NEOJIBA Renovation in Parque do Queimado

Acoustical Design Report

March 28, 2016

Part 4:
Comments on Issued Drawings

JANELA ACUSTICA PLATEIA - FACHADA SUL

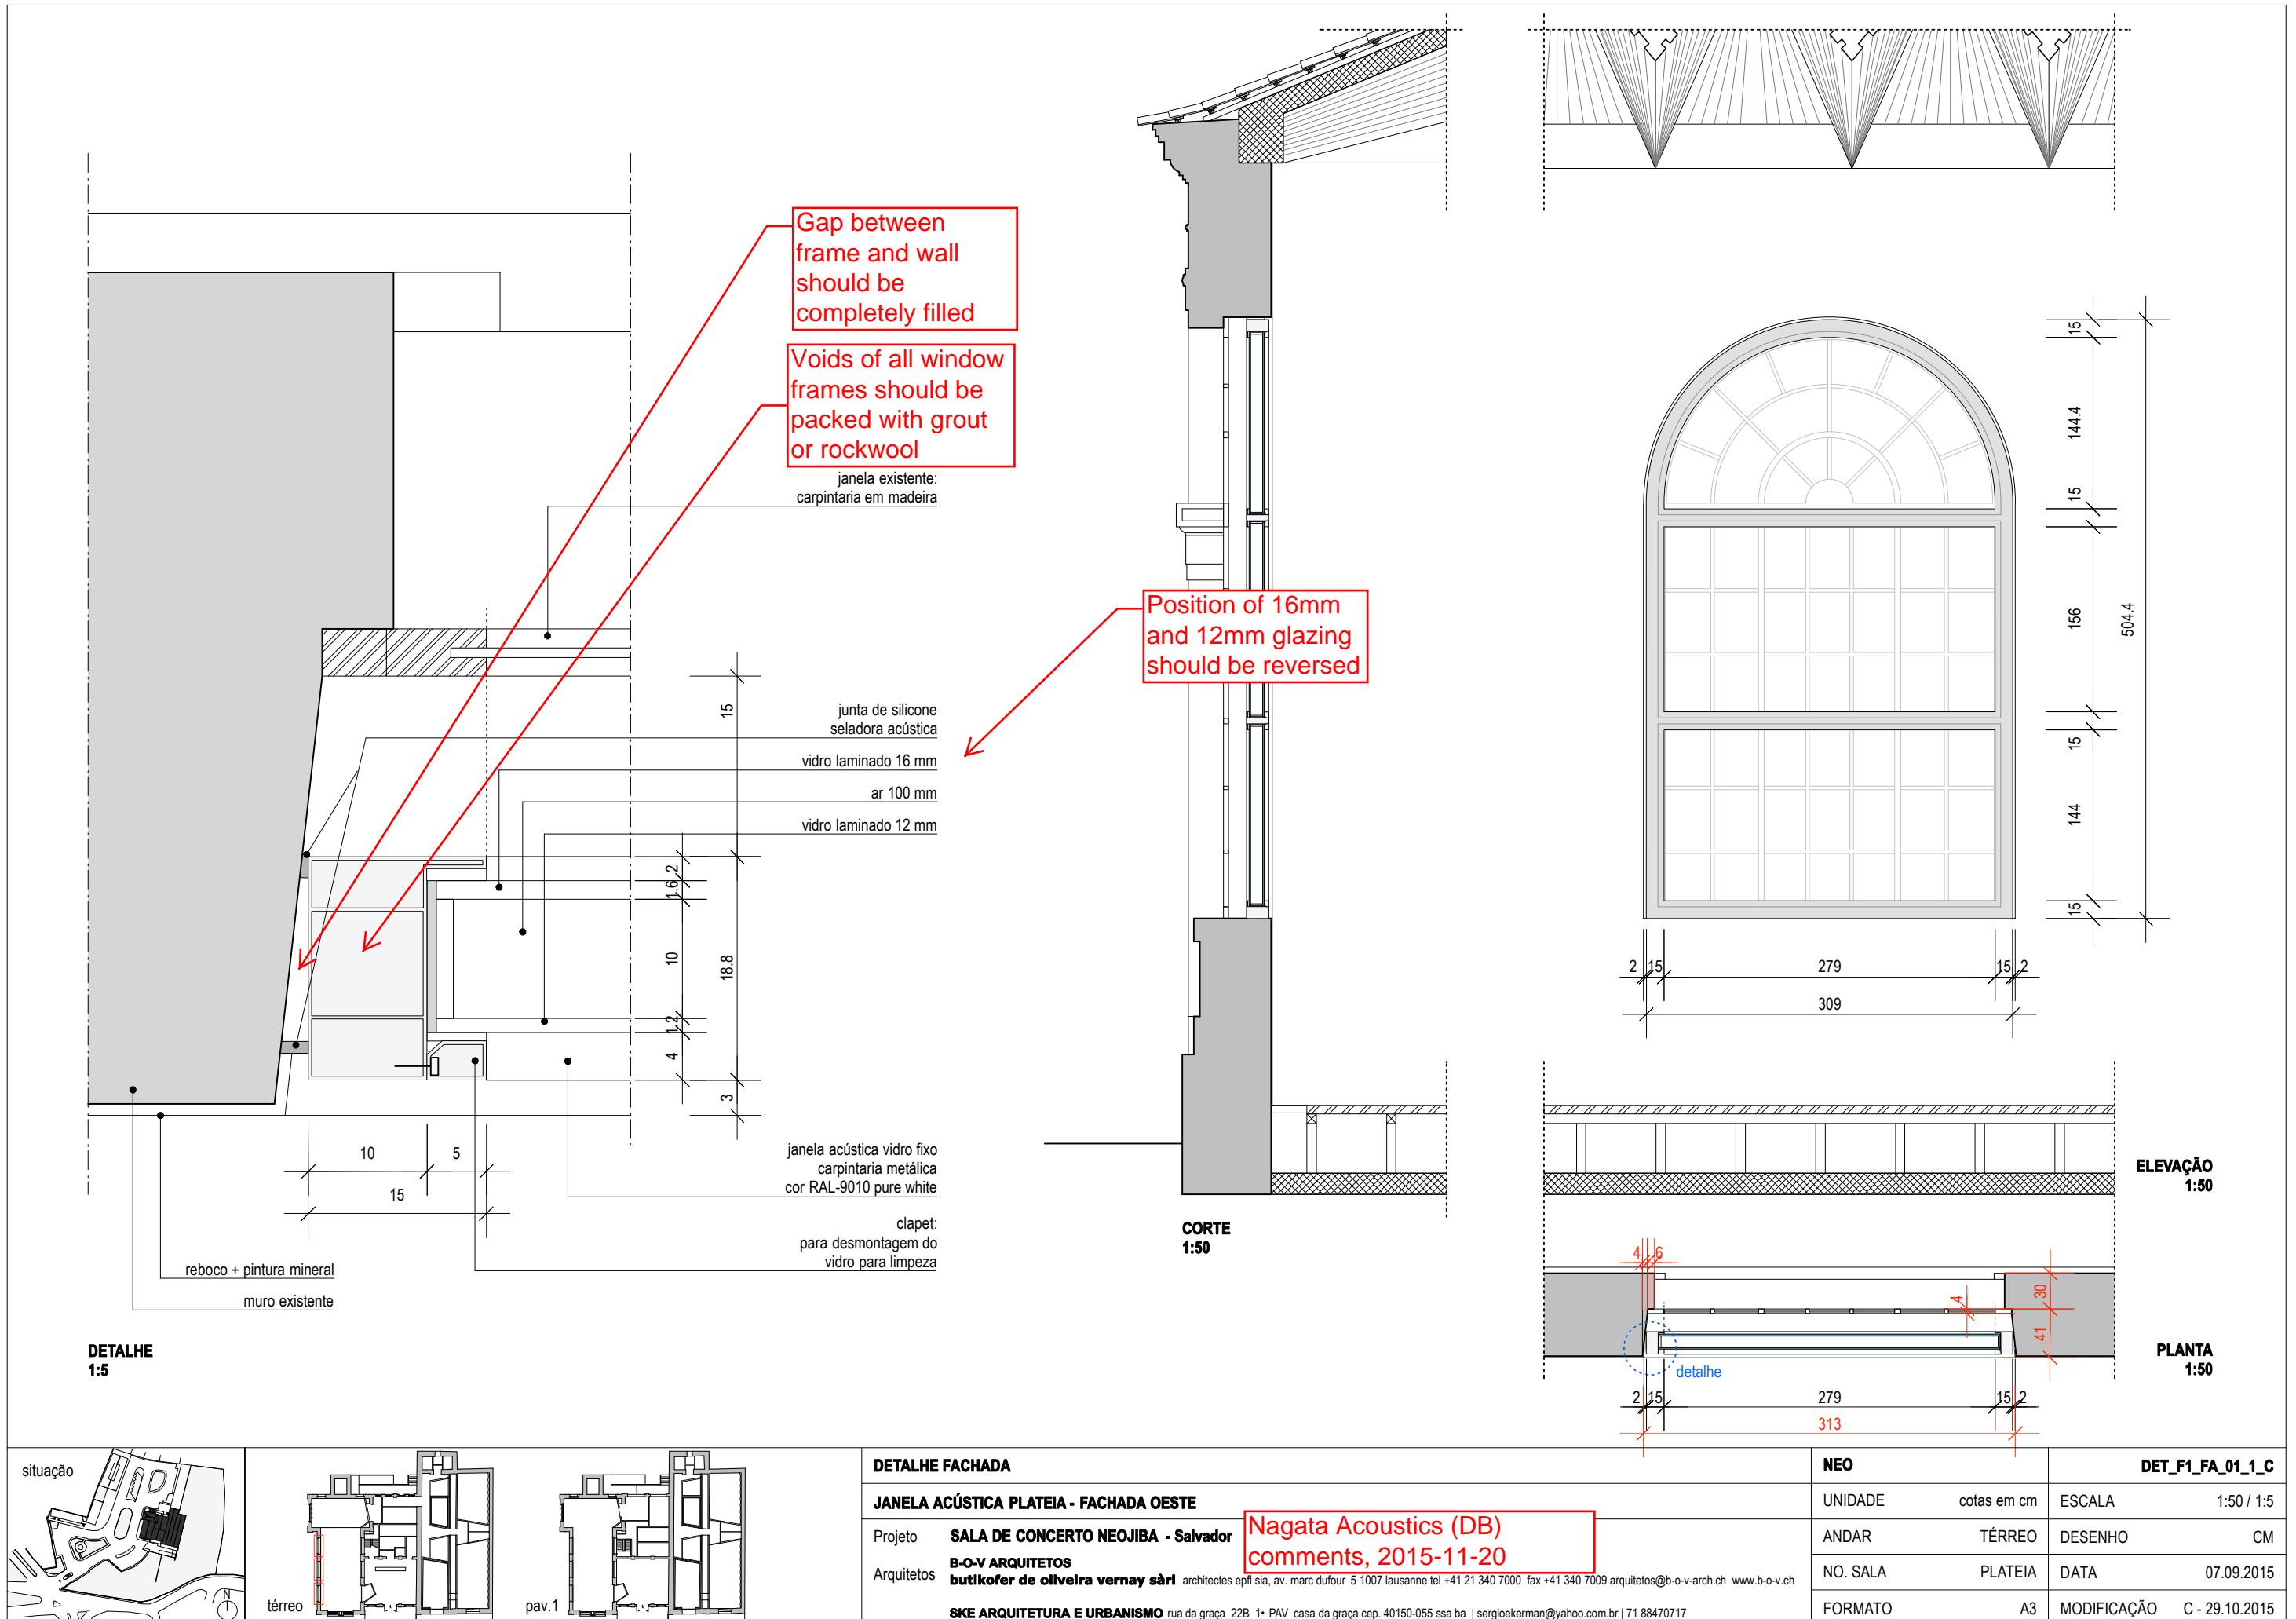
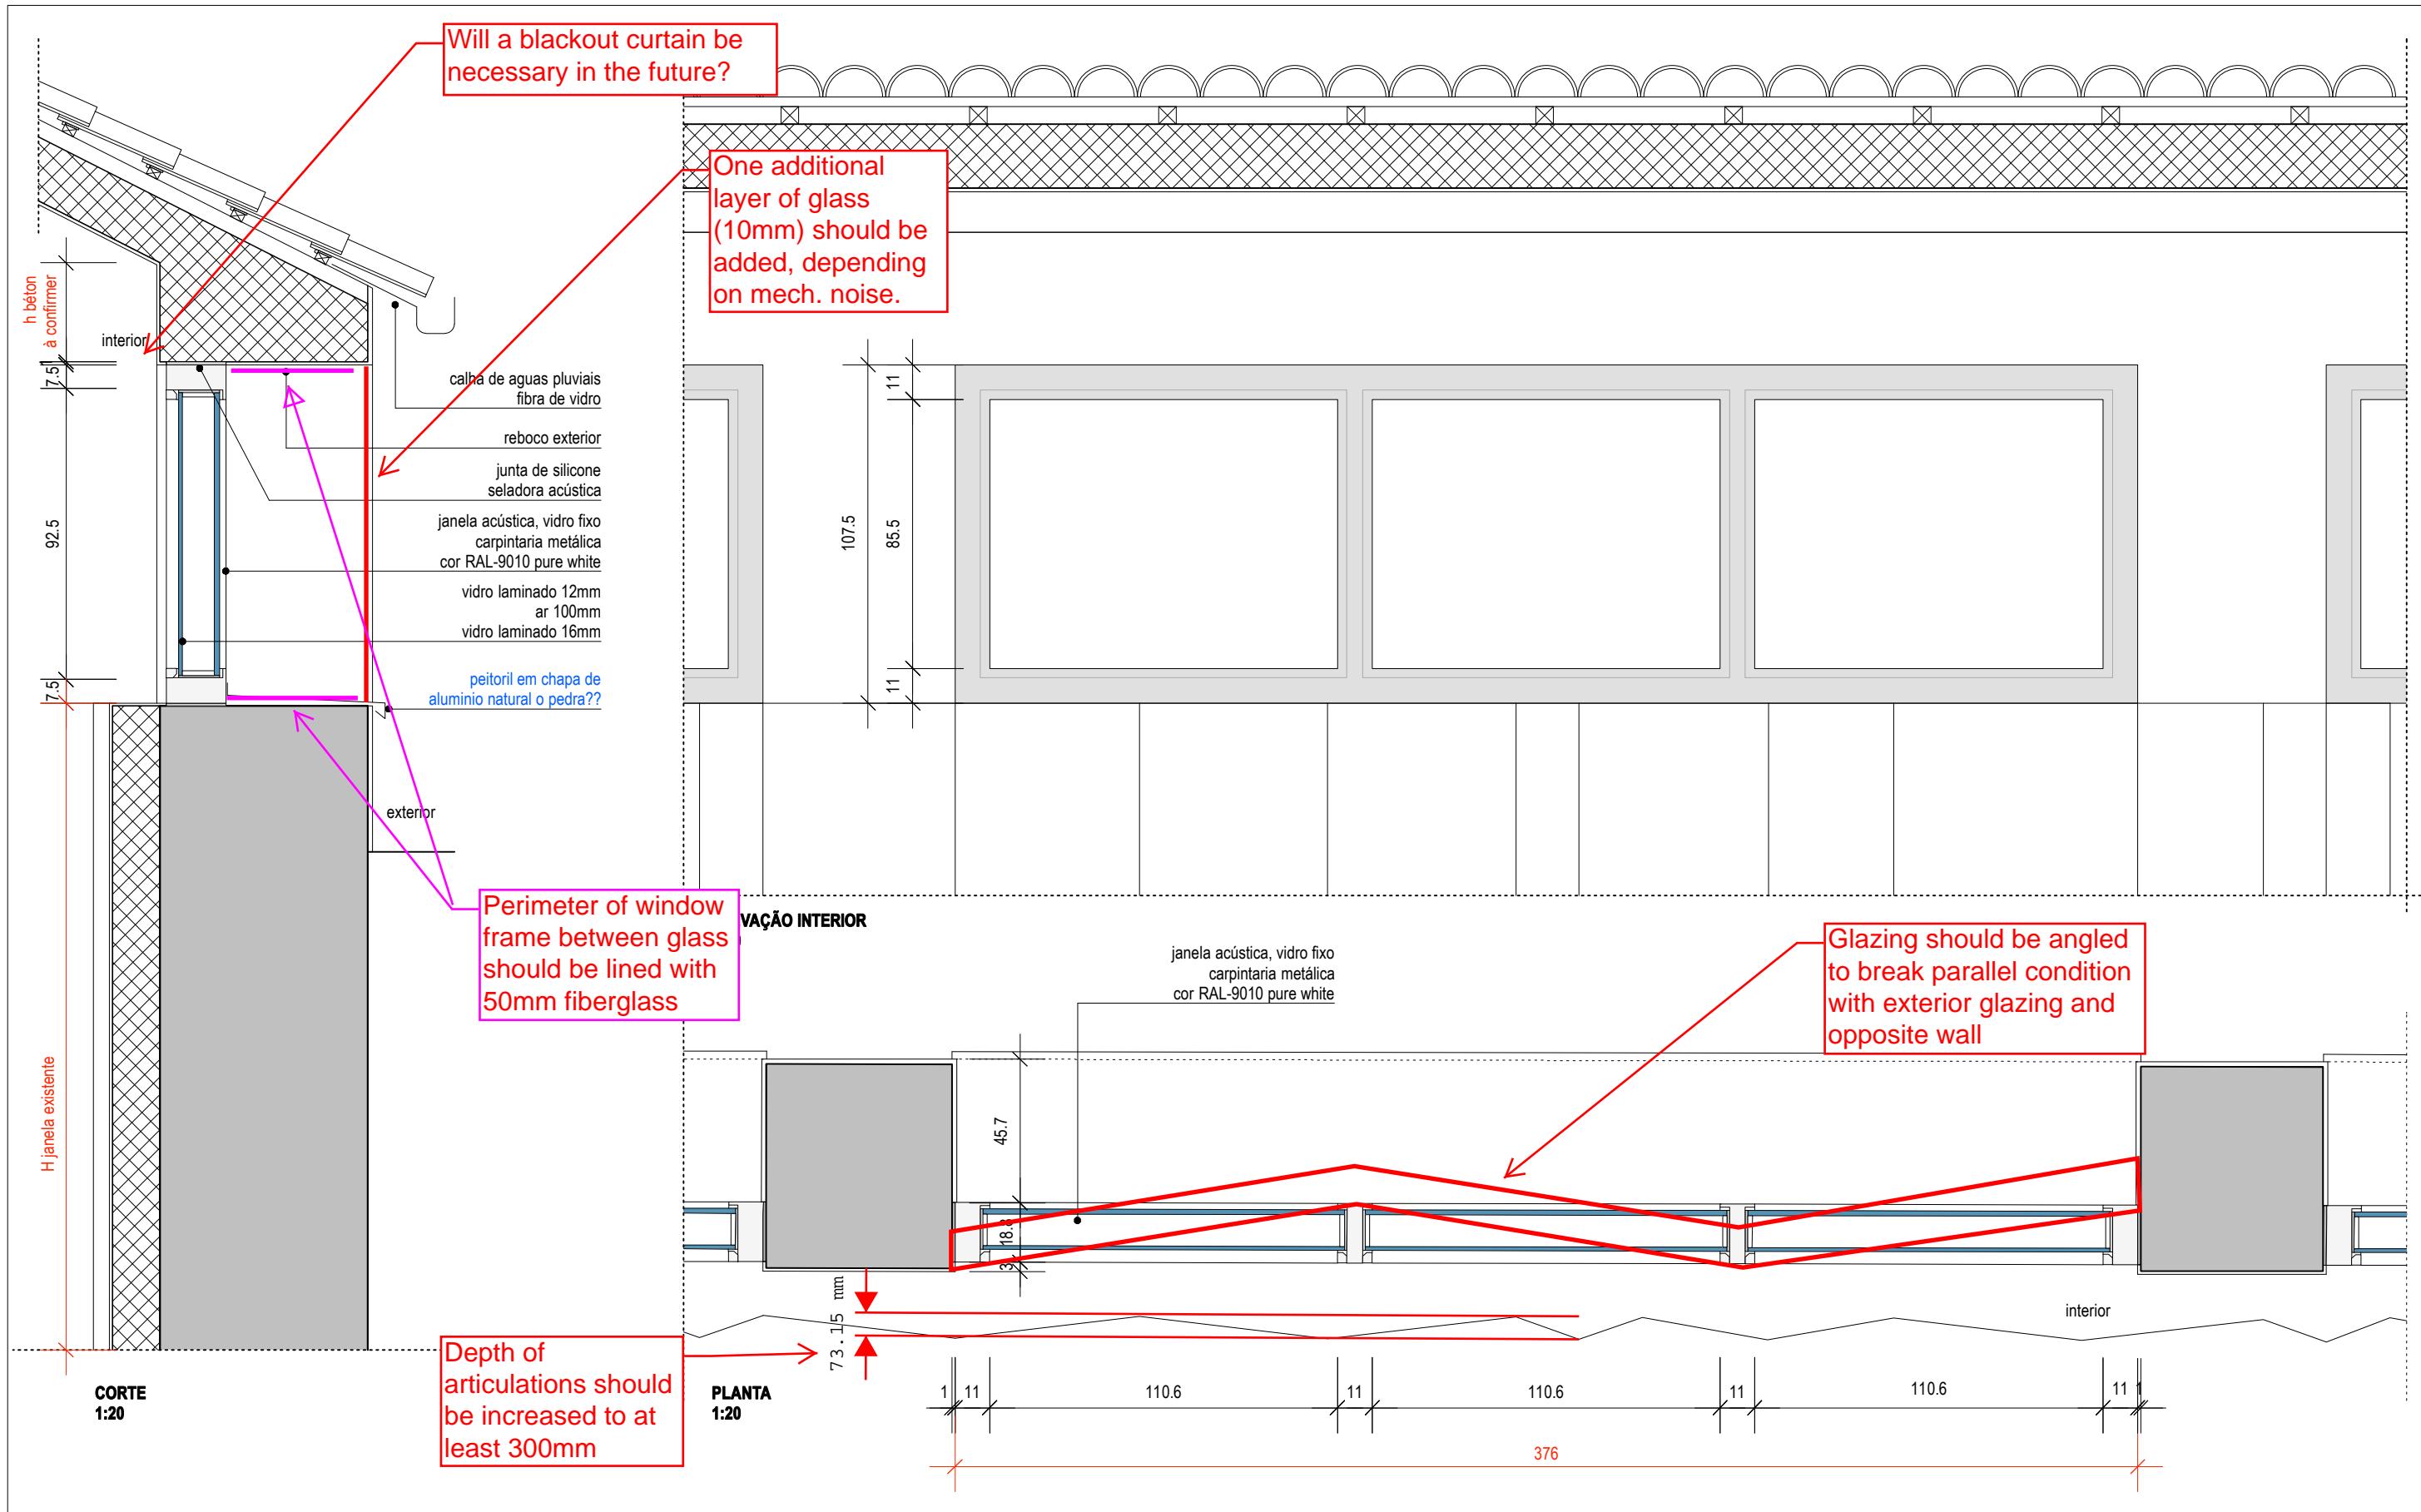
Nagata Acoustics (DB)
comments, 2015-11-20
